SUBJECT: Rolls-Royce Response to Request for Additional Information (Set 3) Re: Rolls-Royce Civil Nuclear "**SPINLINE 3** Digital Safety Instrumentation and Control Platform" Topical Report (TAC NO. ME3600)

RESPONSE TO REQUEST FOR ADDITIONAL INFORMATION (SET 3)
ROLLS-ROYCE **SPINLINE 3** DIGITAL SAFETY
INSTRUMENTATION AND CONTROL PLATFORM
PROJECT NO. 773

Figure 1 – OSS Architecture Illustration

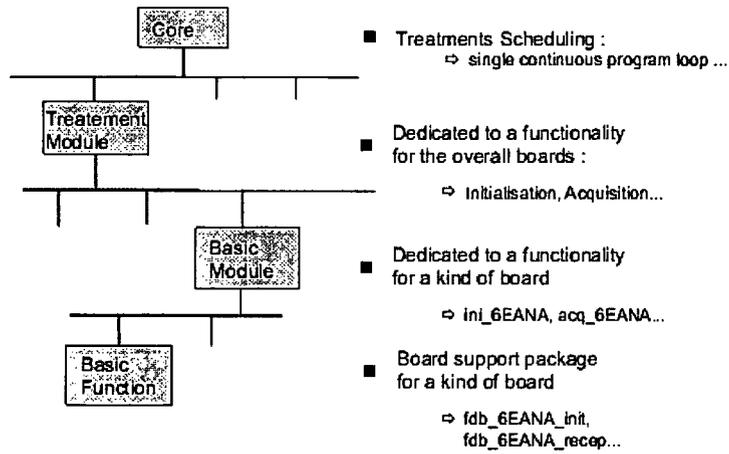
The LTR, Section 4.4.2 and 6.1, briefly describe that the Core System Software (CSS) and the Basic Functions (BFs) are part of the OSS. However, it is not clear how the CSS and BF work. In particular the LTR does not clearly describe how the CSS manages the environment in which the OSS elements operate. Also, the LTR does not describe how the BF transfers or exchanges data between the OSS and the CSS, and the input/output (I/O) modules, and then how this data is transferred and used by the application software.

Please clarify the relationship between the OSS, BF, and the CSS. Also please explain the use of configuration tables by the OSS. Note if drawings are provided; please include a description of the drawing and how the information depicted relates to operation of the SPINLINE 3 platform.

Figure 1 (from Rolls-Royce document 1 207 228) illustrates the chained calls from the Cycle Time Management module (Core) to the Treatment Modules, then to the Basic Modules, and down to the Basic Functions. The Core Module, Treatment Modules, and Basic Modules are part of the CSS.
